**ADDENDUM NO. 1
TO THE
BIDDING DOCUMENTS
FOR
BID NUMBER #24210
WRF IMPROVEMENTS**

PW # 2022.117, 2022.118, 2022.119, 2022.120

**FOR
LAKE COUNTY DEPARTMENT OF PUBLIC WORKS**

DATE: February 8, 2024

050-R-2

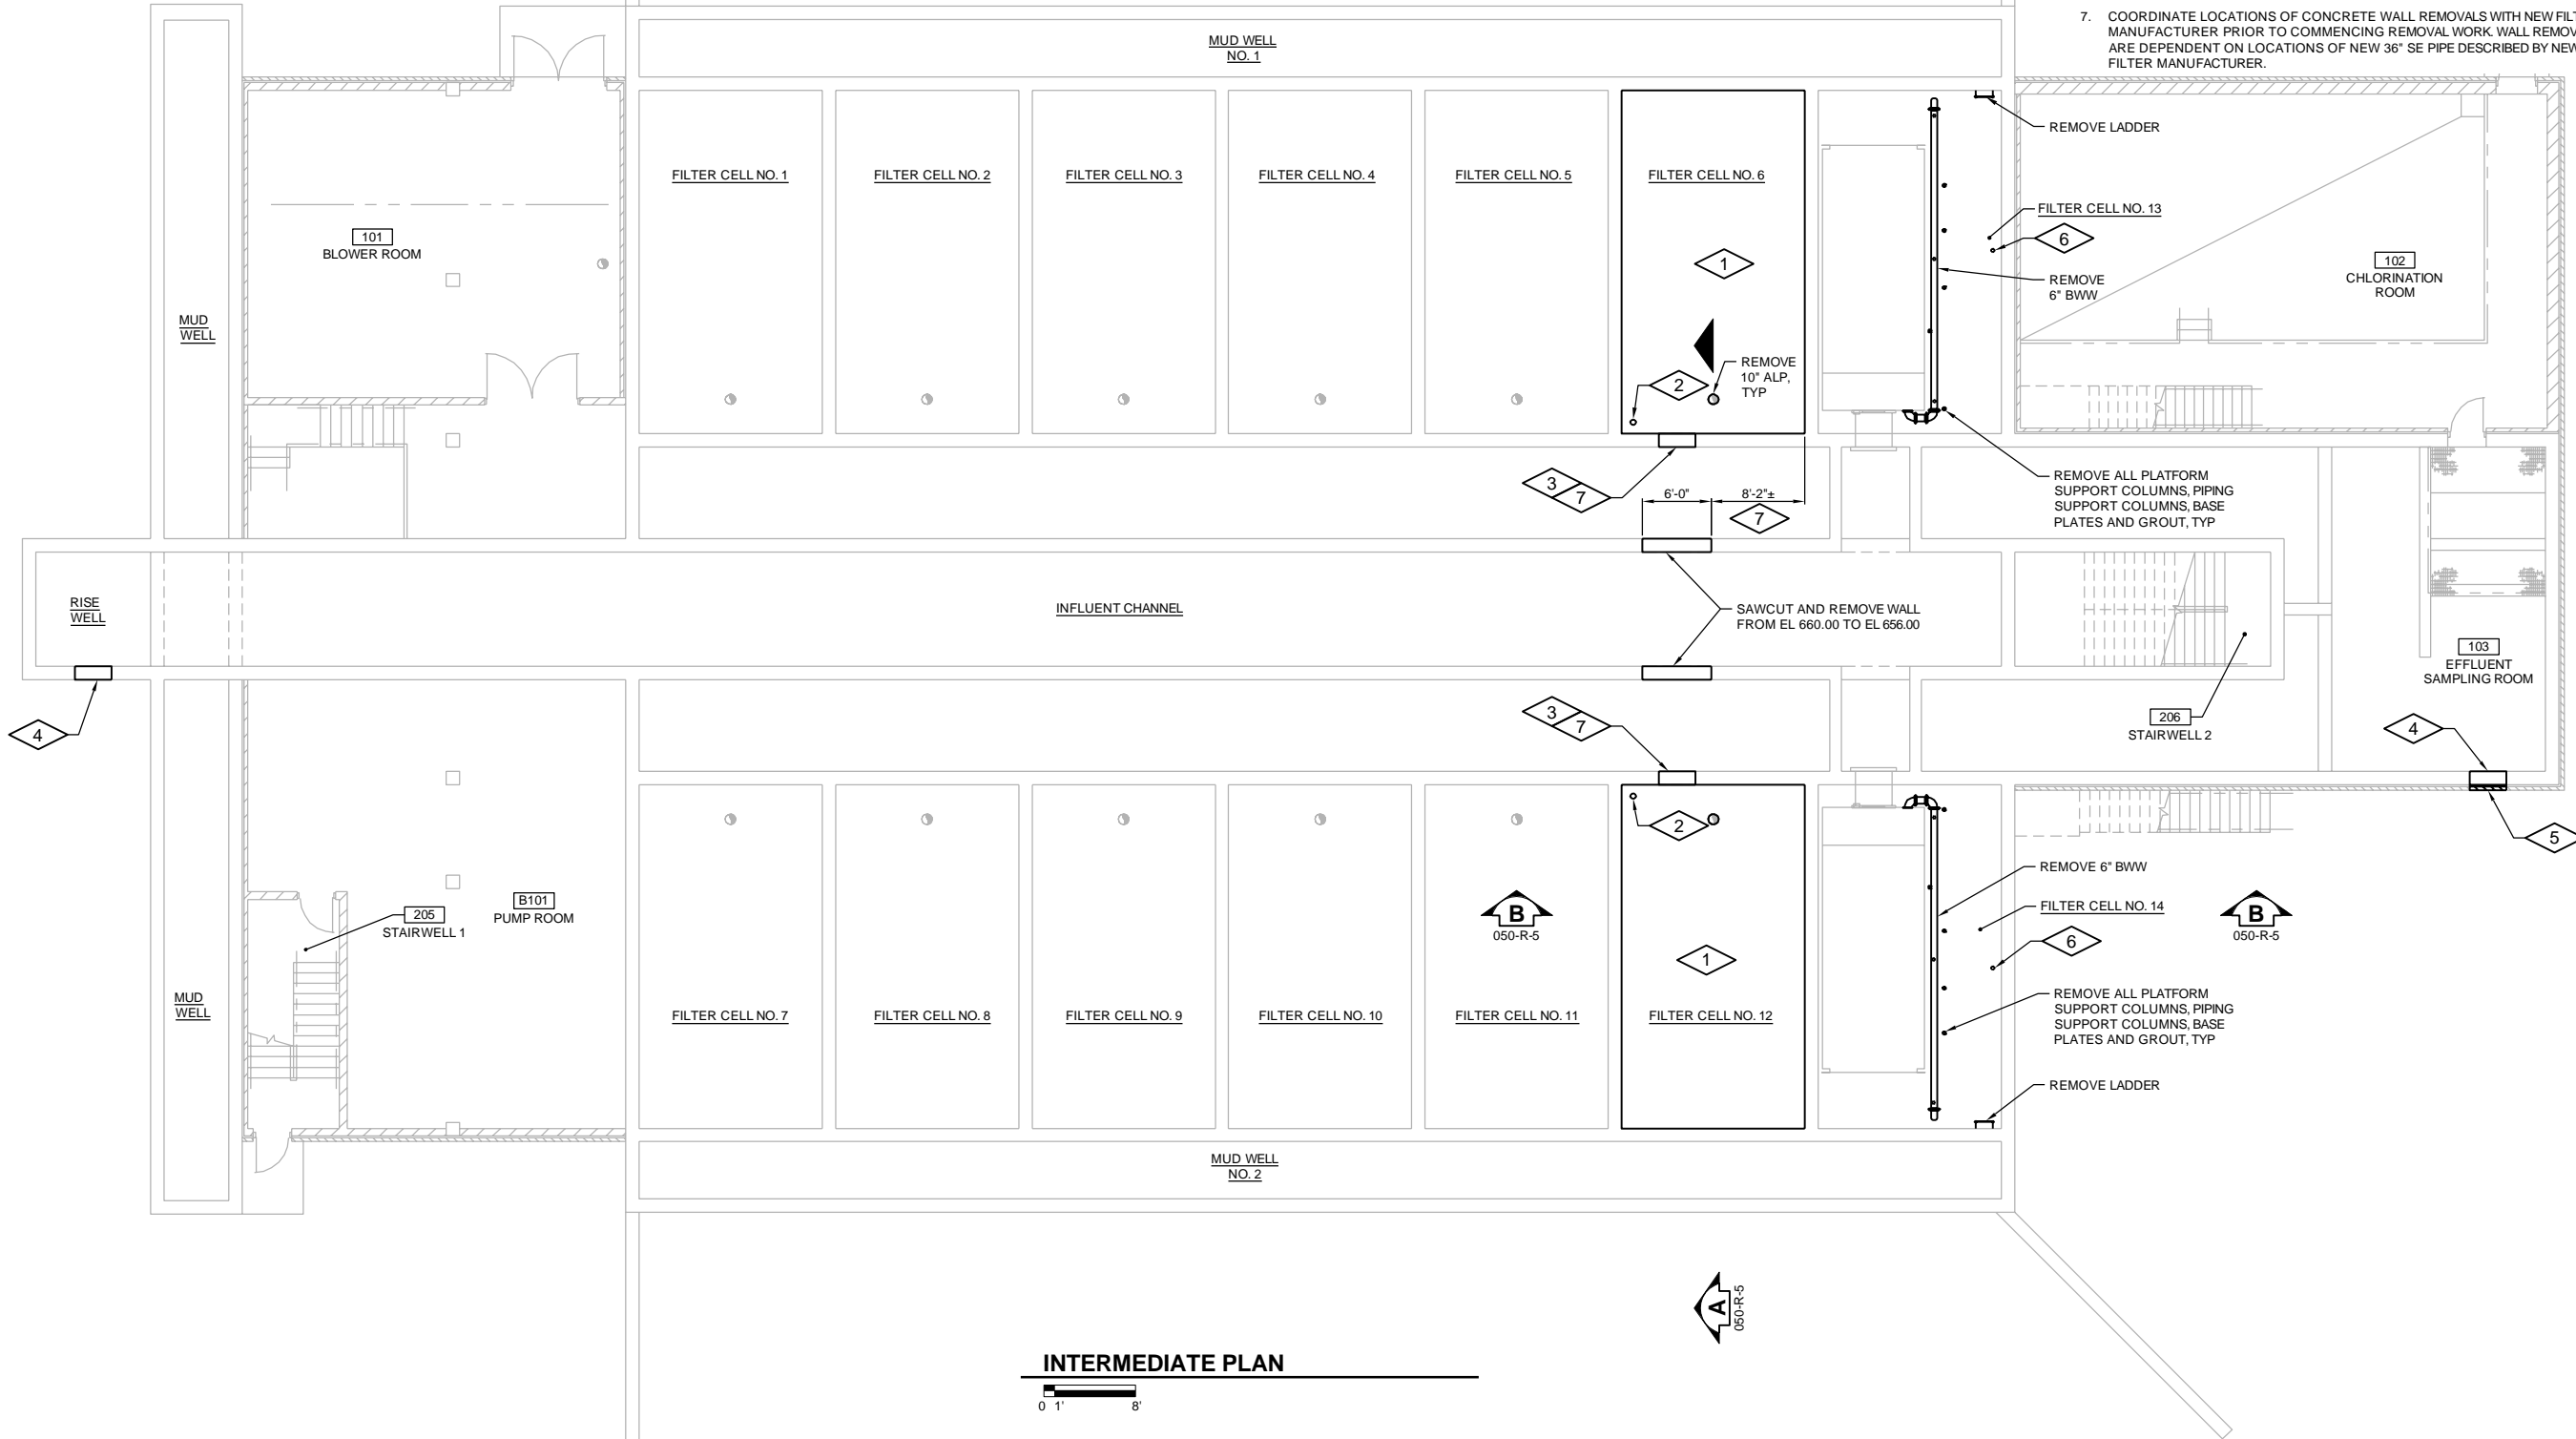
1. Sheet 24, Drawing 050-R-2, delete Drawing 050-R-2 and add a revised Drawing 050-R-2 attached to this Addenda.
2. Sheet 29, Drawing 050-S-2, delete Drawing 050-S-2 and add a revised Drawing 050-S-2 attached to this Addenda.
3. Sheet 37, Drawing 050-M-2, delete Drawing 050-M-2 and add a revised Drawing 050-M-2 attached to this Addenda.
4. Sheet 40, Drawing 050-M-5, delete Drawing 050-M-5 and add a revised Drawing 050-M-5 attached to this Addenda.

- CONTRACTOR TO REMOVE ALL CONCRETE FILL DOWN TO BASE SLAB ELEVATION 649.00 AND ALL ASSOCIATED FILTER EQUIPMENT FROM SAND FILTER BASINS. REMOVE DETERIORATED CONCRETE ON WALLS AND FLOOR OF TANK CELLS DOWN TO SOUND CONCRETE. DO NOT CUT OR REMOVE EXISTING REINFORCEMENT IN WALLS OR BASE SLAB. CONTRACTOR TO CLEAN AND PREPARE TANK FOR NEW WORK.

- REMOVE BALL FLOAT AND ASSOCIATED APPURTENANCES.
- SAWCUT AND REMOVE WALL FOR NEW PROCESS PIPING. SEE M DRAWINGS FOR ADDITIONAL DETAILS AND (S)Z1.
- CORE DRILL AND REMOVE WALL FOR NEW BYPASS PIPING. SEE M DRAWINGS FOR ADDITIONAL DETAILS.

- EXTERIOR BRICK VENEER SHALL BE TEMPORARILY SUPPORTED AS REQUIRED DURING CONSTRUCTION OF BYPASS PIPING. SEE M DRAWINGS FOR DETAILS. SALVAGE REMOVED BRICK FOR REINSTALLATION.

- REMOVE STEM ON EXISTING MUD VALVE. SALVAGE STEM MOUNTING BRACKET FOR REINSTALLATION.
- COORDINATE LOCATIONS OF CONCRETE WALL REMOVALS WITH NEW FILTER MANUFACTURER PRIOR TO COMMENCING REMOVAL WORK. WALL REMOVALS ARE DEPENDENT ON LOCATIONS OF NEW 36" SE PIPE DESCRIBED BY NEW FILTER MANUFACTURER.
